NATIONAL TRANSPORTATION SAFETY BOARD

Group Chairman's Factual Report

WPR11MA454

**NORTH AMERICAN—INSTALLATION OF ELEVATOR INERTIA WEIGHT—
P-51B, P-51C, P-51D, F-6C, AND F-6D**

Figure 2 - Views Showing Rework Necessary to Reroute Relief Tube - P-51D Airplanes

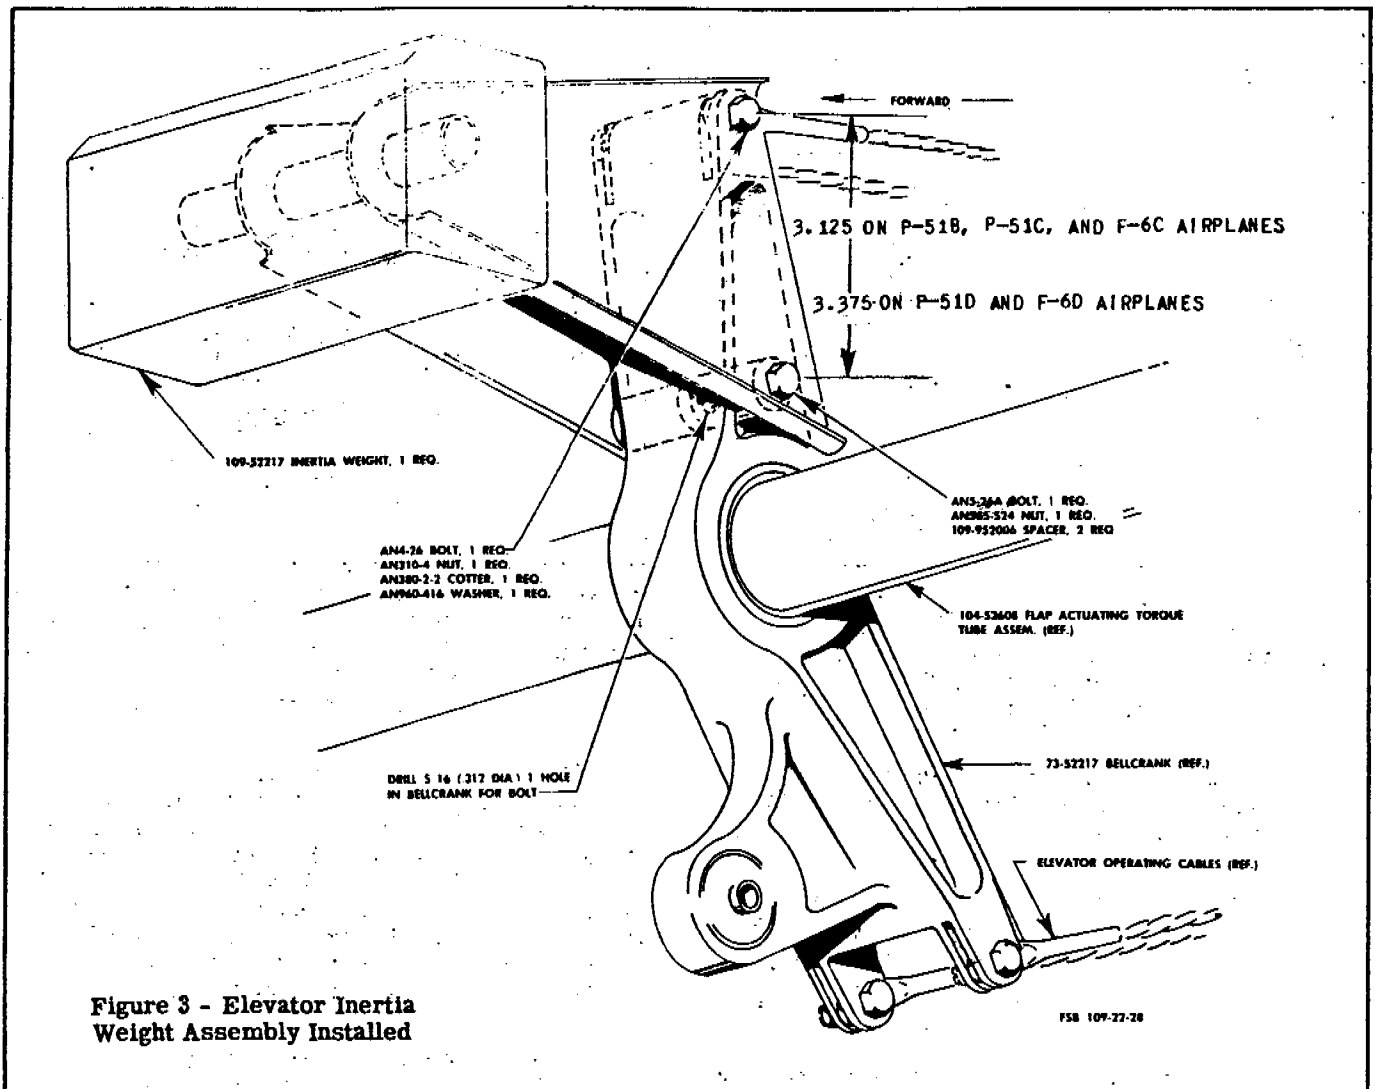
(3) (See figure 2 for the following rework instructions.) Drill a 7/8-inch diameter hole in the web assembly (fuselage station 147-1/4) at a point 5-3/8 inches to the right of existing hole for the relief tube and 2-5/16 inches below the upper edge of the web assembly.

(4) Drill a No. 18 (.169-inch diameter) hole in the channel of the pilot's seat rear armor plate support assembly, as shown in figure 2, to permit installation of a supporting clip for the relief tube when rerouted.

(7) Install the clip, part No. 755-10, spacer, part No. 4S3-8-38, screw, part No. 7S4-832-26, and nut, part No. AN365-832, to secure the relief tube to the channel as shown in figure 2.

Figure 4A - View Showing Location of Additional Hole to Be Drilled in the Elevator Inertia Weight Assembly for Use on P-51B, P-51C, and F-6C Airplanes

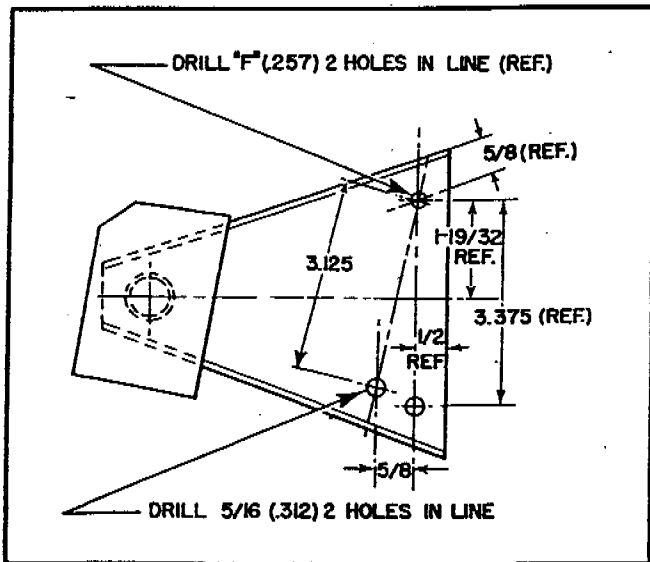
(1) Rework the inertia weight assembly, part No. 109-52217, by relocating the lower attaching hole in the two steel sheets (comprising the supporting bracket for the weight) as shown in figure 4A. Mark the new hole to be drilled and line drill 5/16 (.312) inch diameter two holes through the sheets. In cases where kit "B" parts are used, the steel sheets, part Nos. 109-52217-2 and 109-52217-3, may be drilled before assembly with the lead weight and tube, all of which comprise the inertia weight assembly, part No. 109-52217.

Figure 4B - View Showing Location of Additional Hole to Be Drilled in the Elevator Inertia Weight Assembly for Use on P-51B, P-51C, and F-6C Airplanes if Lower Hole in Bell Crank Has Been Drilled 3-3/8 Inches From Upper Hole

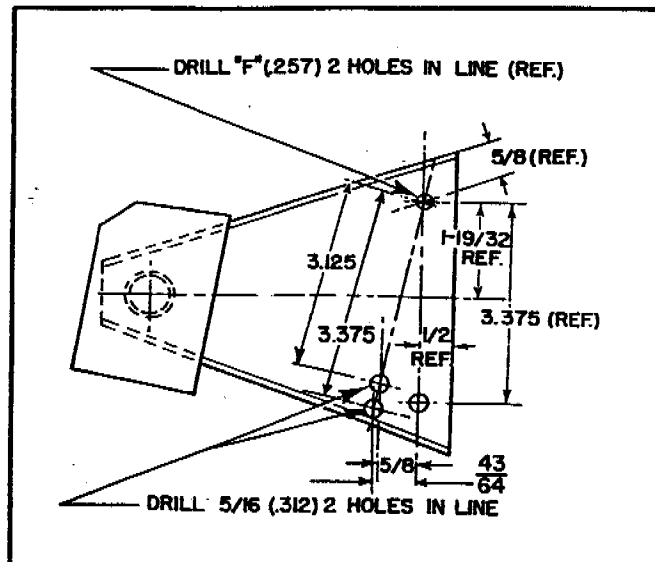
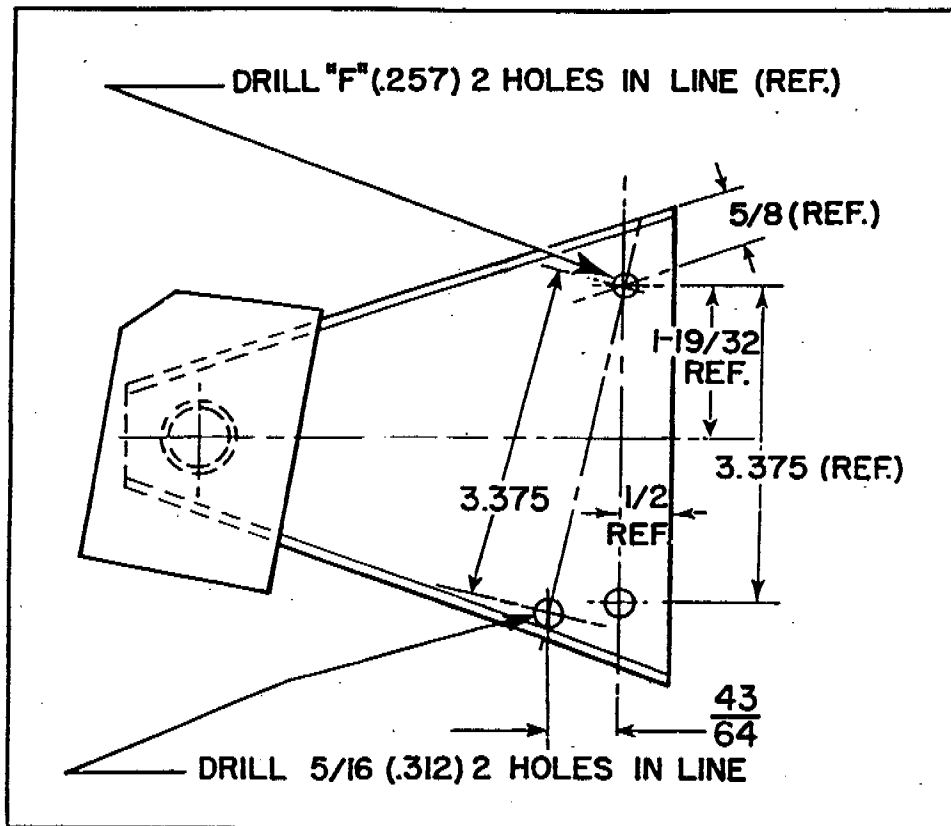
NOTE If the hole referred to in paragraph 2.f.(2) has been drilled at a point 3-3/8 inches below the top hole (figure 3) in attempting compliance with previous instructions contained in T. O. No. 01-60J-29, dated 18 September 1944, it will be necessary to locate

the lower hole in the steel sheets of the inertia weight as shown in figure 4B.

1. Figure 4B of T. O. No. 01-60-90, dated 20 November 1944, is corrected as follows:

Figure 5 - Heating and Ventilating System -
P-51B and P-51C Airplanes

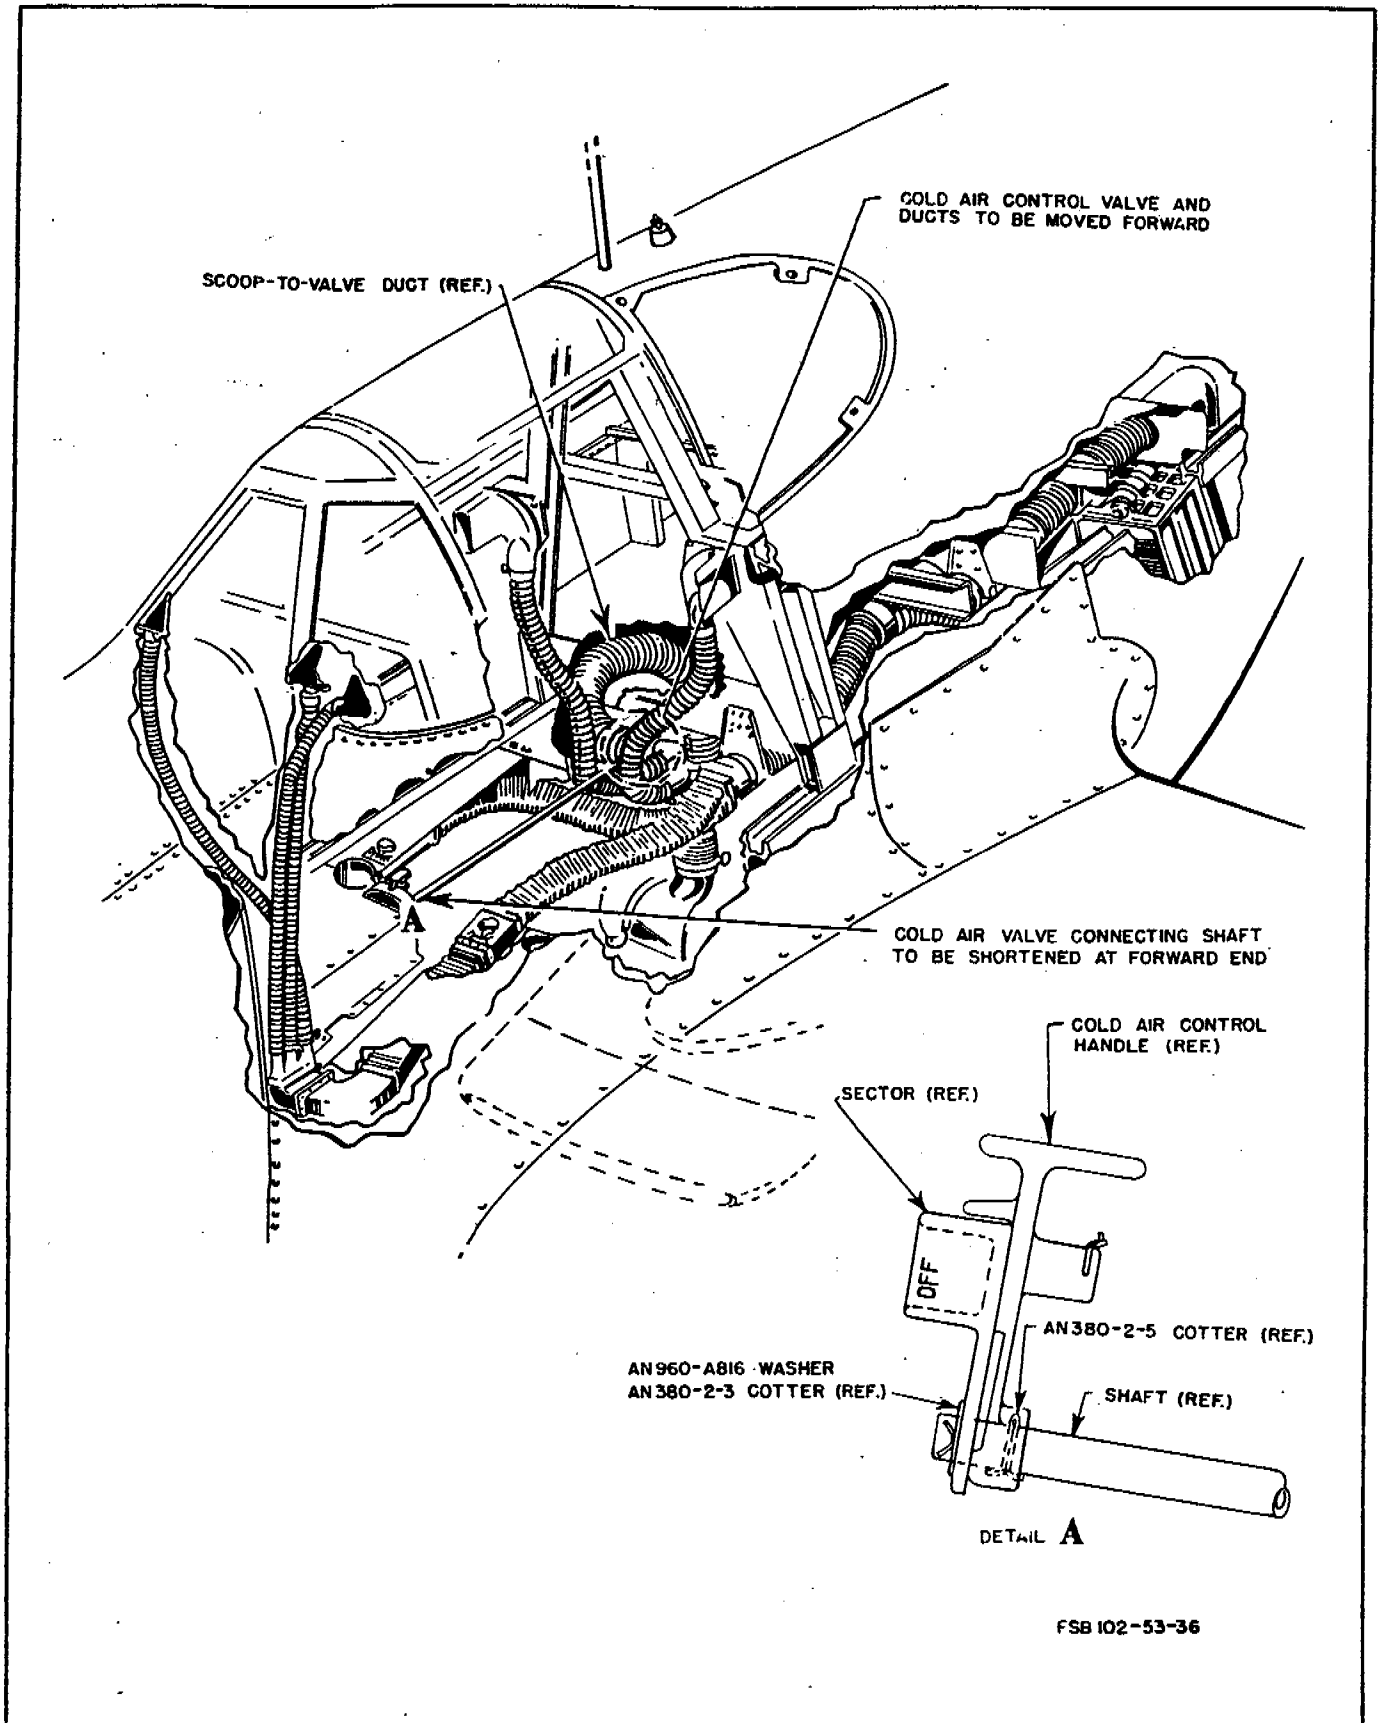
(3) Relocate the cold air control valve, part No. 102-53328, by moving it forward approximately 4 inches as follows: (See figure 5.)

(b) Disconnect the cold air valve connecting shaft at the forward end by removing the screws securing the sector to the floor and removing the cotters securing the handle and sector. Temporarily slide the handle and sector back on the shaft. (See figure 5, detail A.)

(g) Reposition the cold air valve connecting shaft at the forward end, and after making allowance for the sector and handle, cut off the portion of the shaft not required. Drill the No. 48 (.076-inch diameter) two new holes in the shaft for the cotter pins. Reposition the handle and sector on the shaft and secure them with the cotter pins. Reattach the sector to the floor with the screws previously removed. (See figure 5.)

Figure 6 - Relocation of Cold Air Control Valve - P-51B and P-51C Airplanes

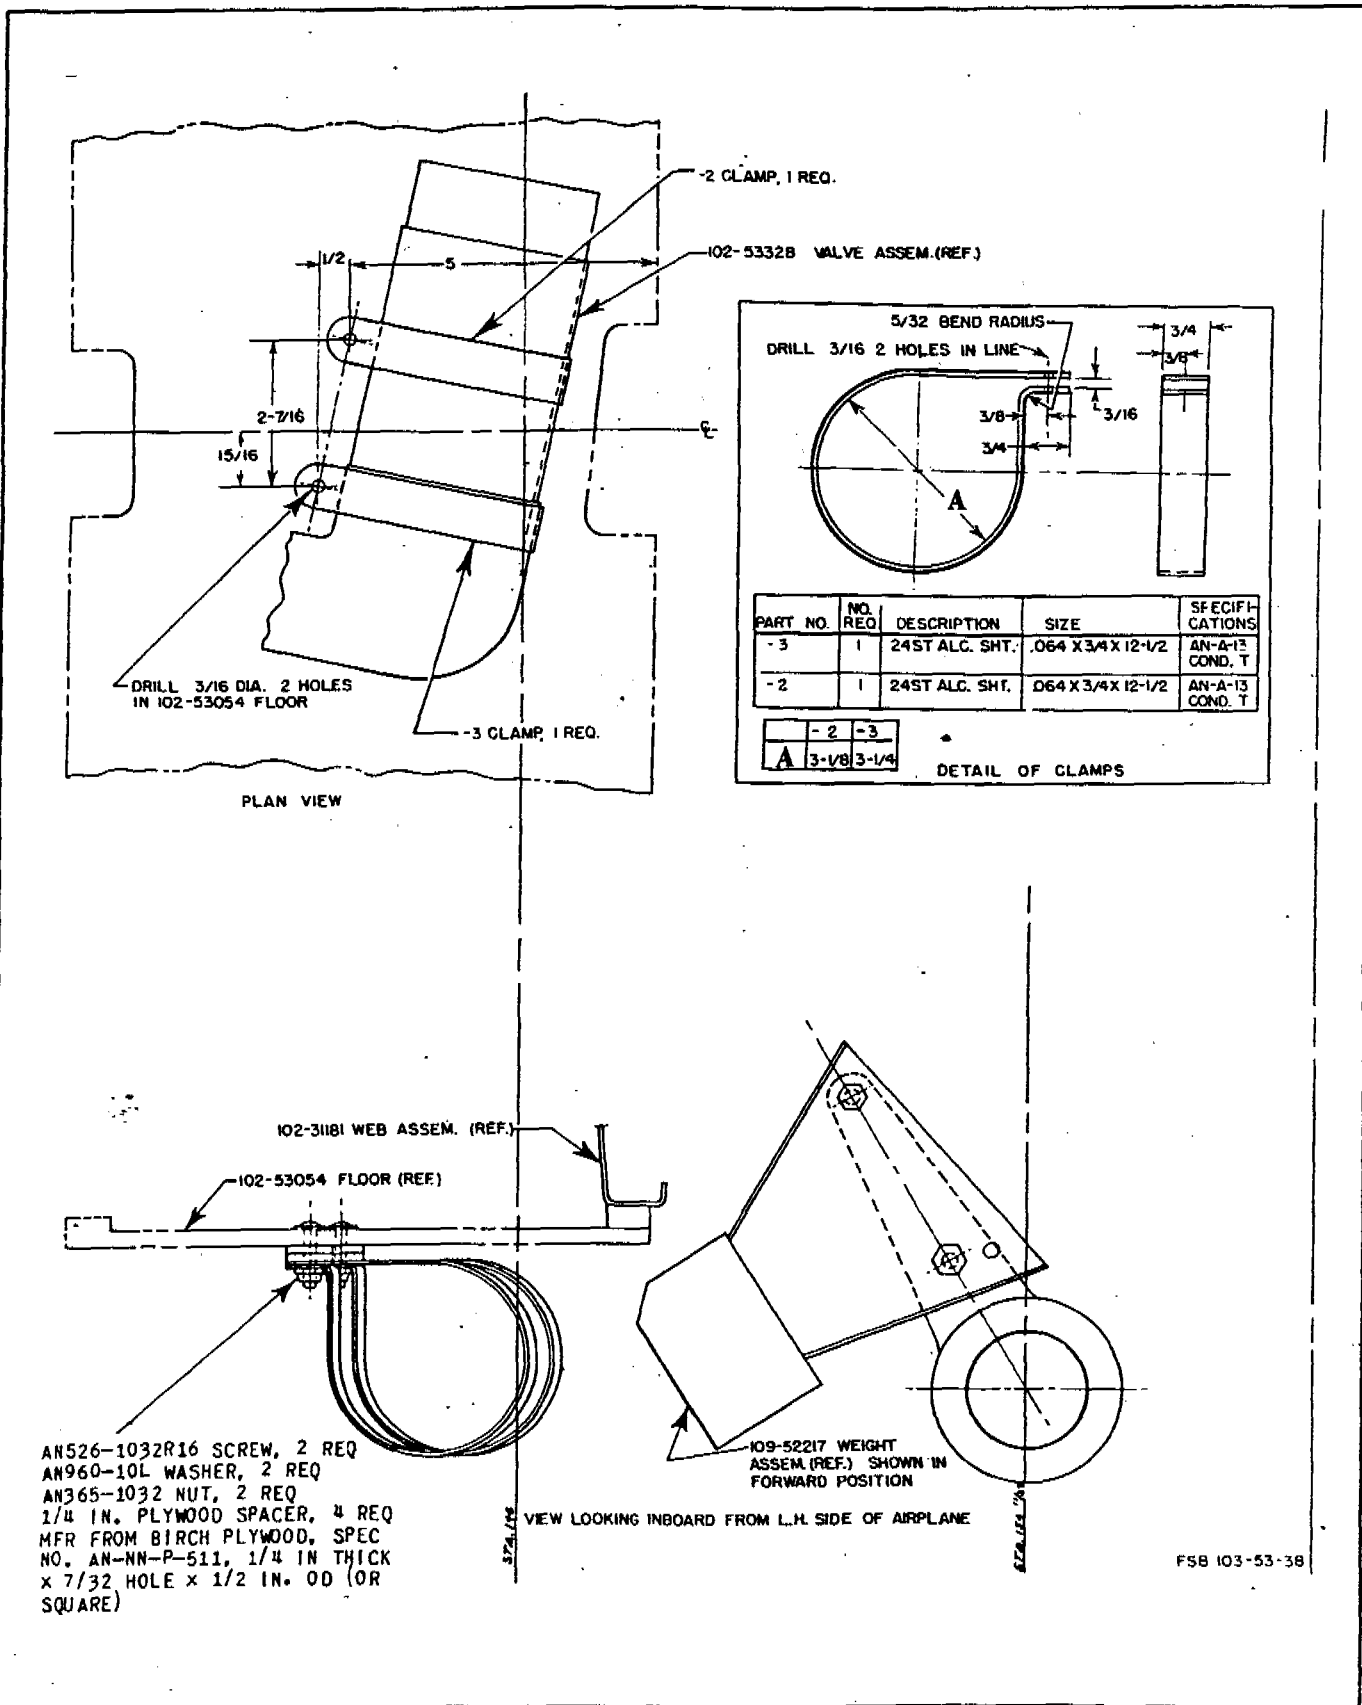
(2) Fabricate the two new clamps, part Nos. -2 and -3, required for the relocation of the cold air control valve as shown in figure 6.

(e) Mark the two holes to be drilled in the floor for the clamps as shown in figure 6. Drill two 3/16-inch diameter holes through the floor.

(f) Reattach the cold air control valve in its new location (figure 6) using the two new clamps, part Nos. -2 and -3, screws, part No. AN526-1032R16, washers, part No. AN960-10L, nuts, part No. AN365-1032, and plywood spacers. Reconnect the shaft to the valve.

Figure 1 - View Showing Rear Casting Installed - Horizontal Stabilizer

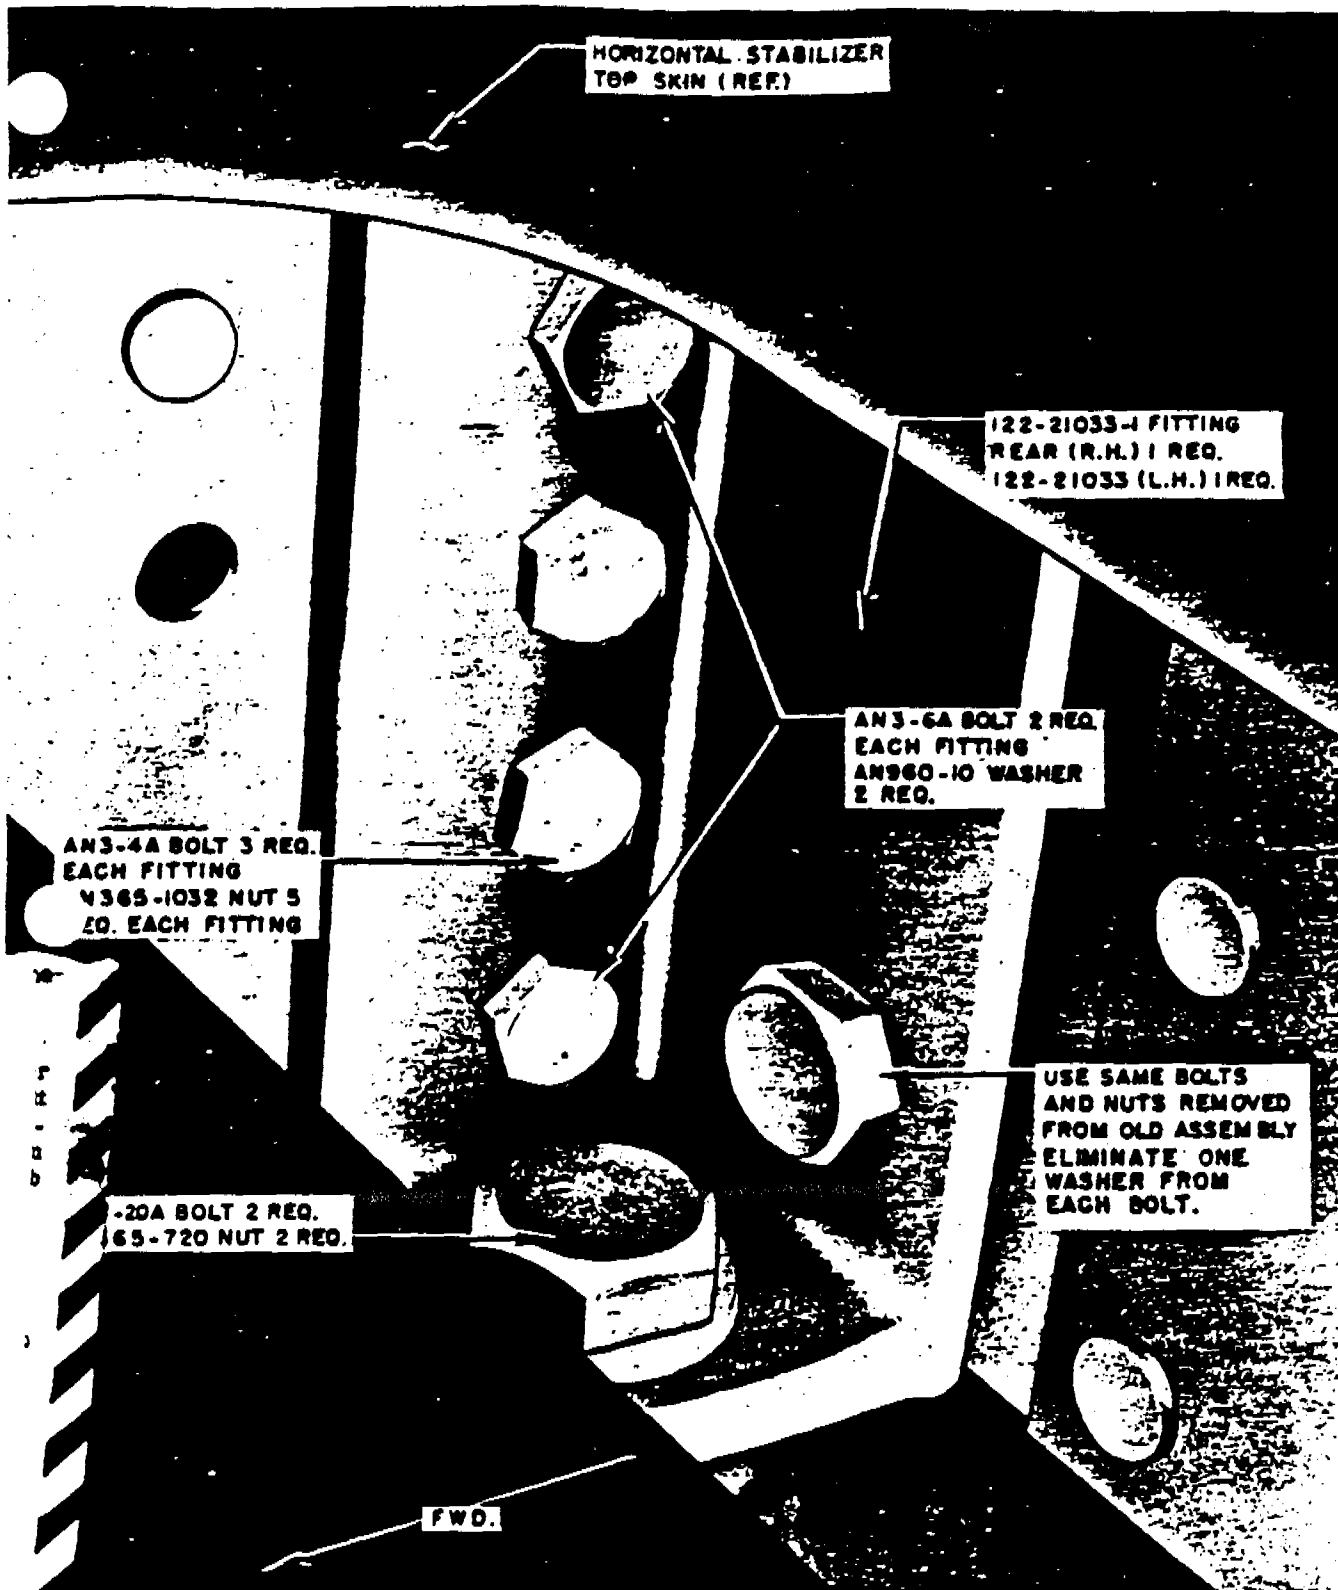
(2) Remove the two bolts and nuts securing each of the two rear castings to the horizontal stabilizer. Remove the three rivets securing each casting. (See Figure 1.)
